V8 XJ Series/XK8

303-28

TECHNICAL BULLETIN

Revised Camshaft Drive Operations – Use Ball-ended Hex Drive Bit

ILLUSTRATION 1

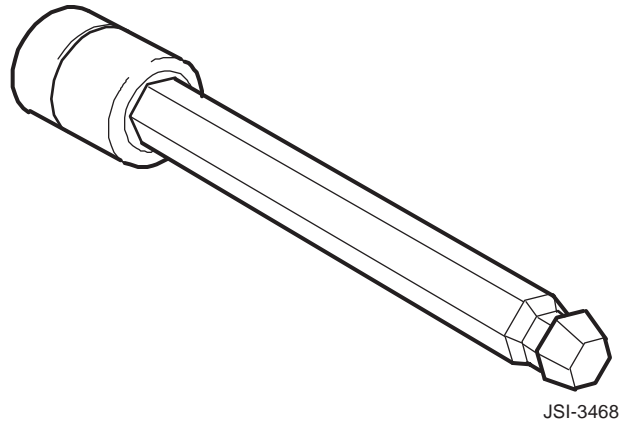
Use a 10 mm ball-ended hexagon drive bit, such as Snap-on FABLM10E, or equivalent (Illustration 1), to remove and retorque the retaining bolt of the exhaust camshaft without removing the timing cover (Illustration 2).

ILLUSTRATION 2

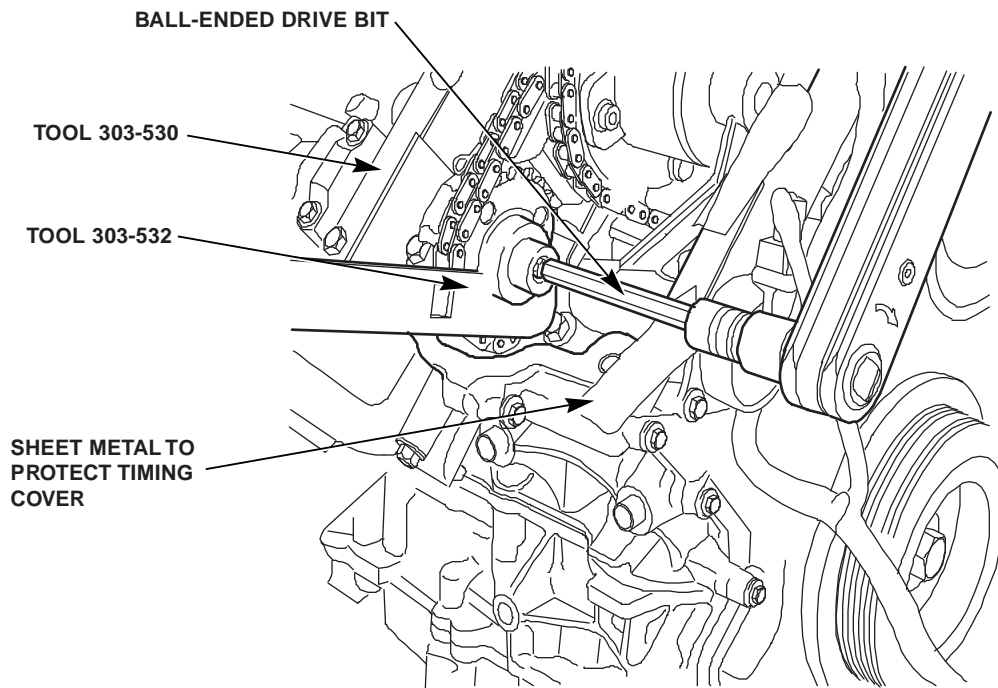
6. Install the camshaft setting tool 303-530 (JD 215) and securing bolts.	AS IN JTIS 4 NO CHANGES
7. Position a length of steel strip (approx 150 x 15 x 3 mm) along the top joint face of the timing cover (Illustration 2) and secure it in position with adhesive tape, to protect the machined upper face of the timing cover from any damage from the use of the ball-end drive bit during following operations. IMPORTANT: IF THE SPROCKET RETAINING BOLT ON THE CAMSHAFT ON THE OTHER BANK OF THE ENGINE IS ALSO TO BE REMOVED OR RETORQUED, MAKE SURE THAT THE STEEL STRIP IS ALSO TRANSFERRED SO THAT THE UPPER MACHINED FACE OF THE TIMING COVER IS ALWAYS PROTECTED WHENEVER THE BALL-ENDED DRIVE BIT IS IN USE.	IMPORTANT CHANGE

8. Apply a Snap-on FABLM10E or equivalent ball-end drive bit and square-drive wrench to the camshaft sprocket securing bolt, loosen and remove the bolt. (See Illustrations). IMPORTANT: DURING THIS AND ANY SUBSEQUENT OPERATIONS ENSURE THAT NOTHING IS DROPPED INTO THE OPEN TIMING CASING. Access is now available for the other listed repair operations that require removing the exhaust camshaft sprocket retaining bolt.	CHANGE AS JTIS 4
